Land West of Market St, Edenfield (H66)  
Revised Masterplan (Version 4) submitted in May 2024  
**Responses Received**

H66 Masterplan (Taylor Wimpey, 2024)

**Figure 1:** Extract from Applicant’s Parking Beat Survey Data

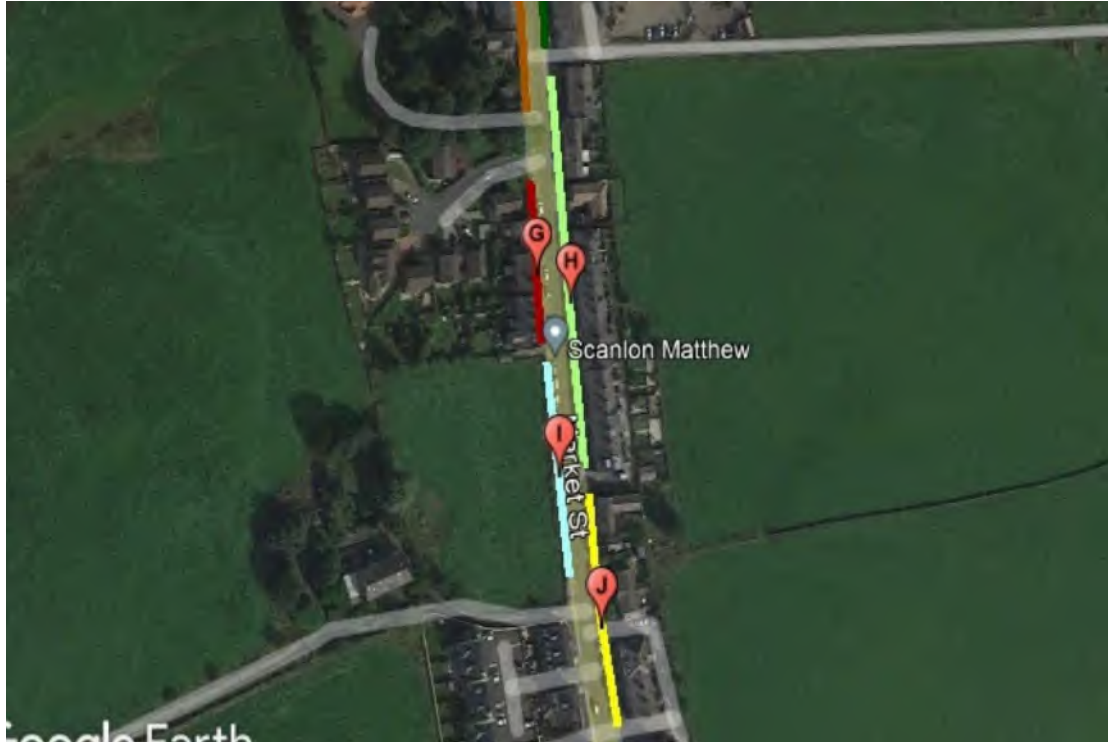
- J – 8 vehicles

This equates to a total of 39 parked vehicles parked on-street in the immediate vicinity of the proposed main site entrance on Market Street. Applying a 6m bay space length would mean 234m of kerbside parking would be required in this location to accommodate this parking demand.

**Figure 2:** Extract from Applicant's Corridor Improvement Strategy (April 2024 Randall Thorp Report)

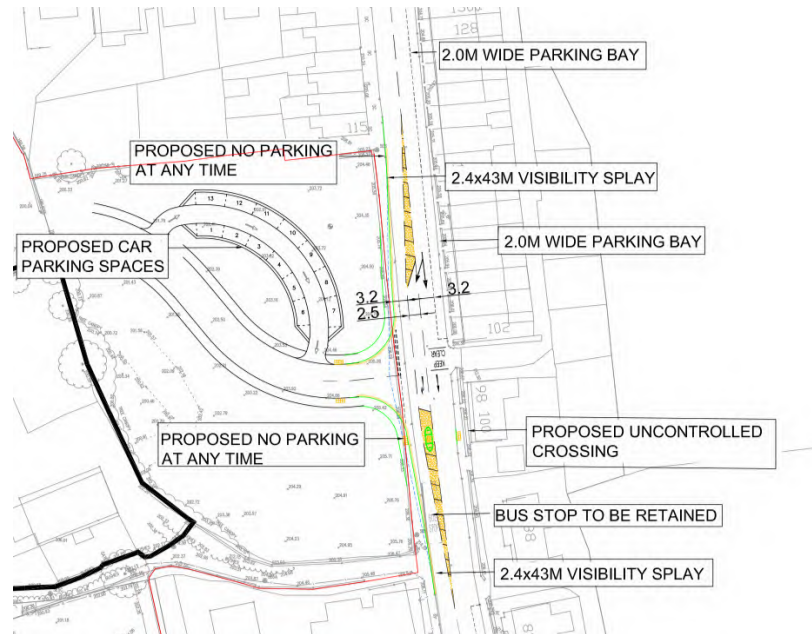
As shown in **figure 2** below the proposed design does not meet the design requirements set out above for the width of the ghosted right turn lane. Paragraph 6.10 confirms 3m is the minimum width for a new junction, and is required to ensure a motorist can safely wait whilst turning right clear of oncoming traffic and to avoid vehicles blocking southbound ahead movements.

A 2.5m wide right turn pocket does not meet the requirements of CD123 for a new junction. It is 0.5m narrower than the minimum 3m wide pocket for a new junction.

In addition, with the access proposals not delivering a 2m wide footway on the eastern side of Market Street, the design as proposed cannot be considered appropriate to serve a new residential development of any scale.
